Design, Furnish and Install Video Wall QA2 _3/30/2010
Proposal Due Date 4/20/2010

Statewide Transportation Operations Center

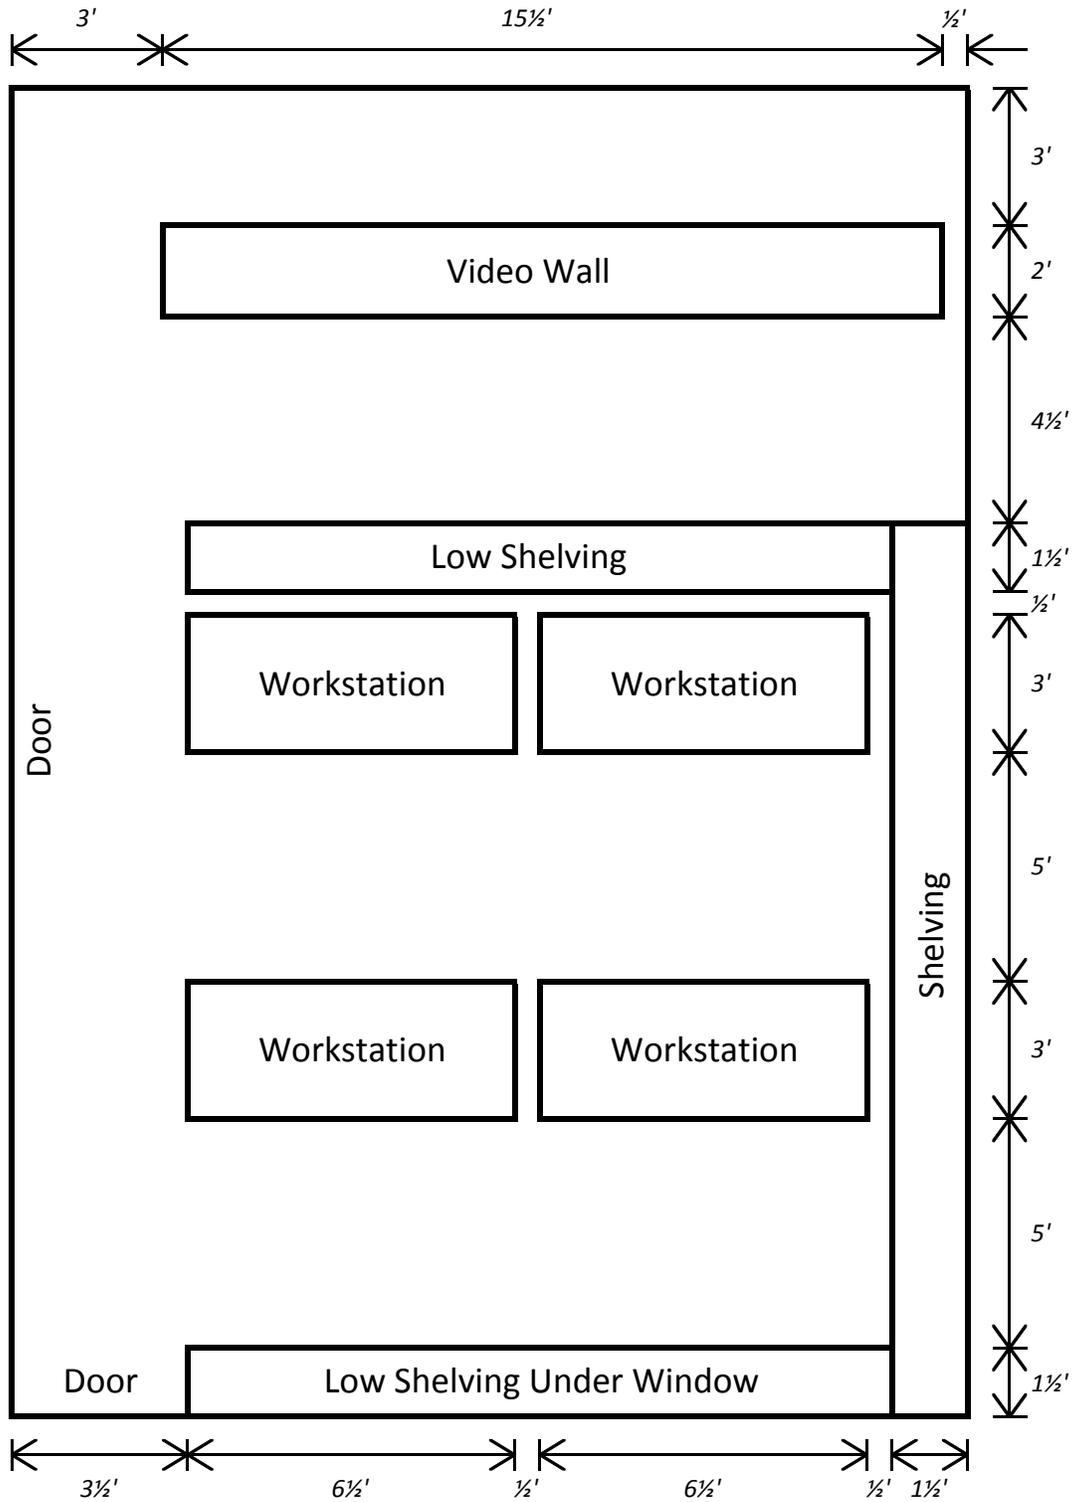
Q6. Are there plans showing the room dimensions, including ceiling height, and console layout? If no plans are available, what is the display wall width and height and how far from the display wall will each row of operators be?

Q11. Section 3.1 states that the design will be based on "existing console furniture layout for the Control Room." Please provide plans for the existing console furniture layouts.

A7. A sketch of the proposed room layout is attached.

A11. A sketch of the proposed room layout is attached.

Floor to Ceiling = 9'
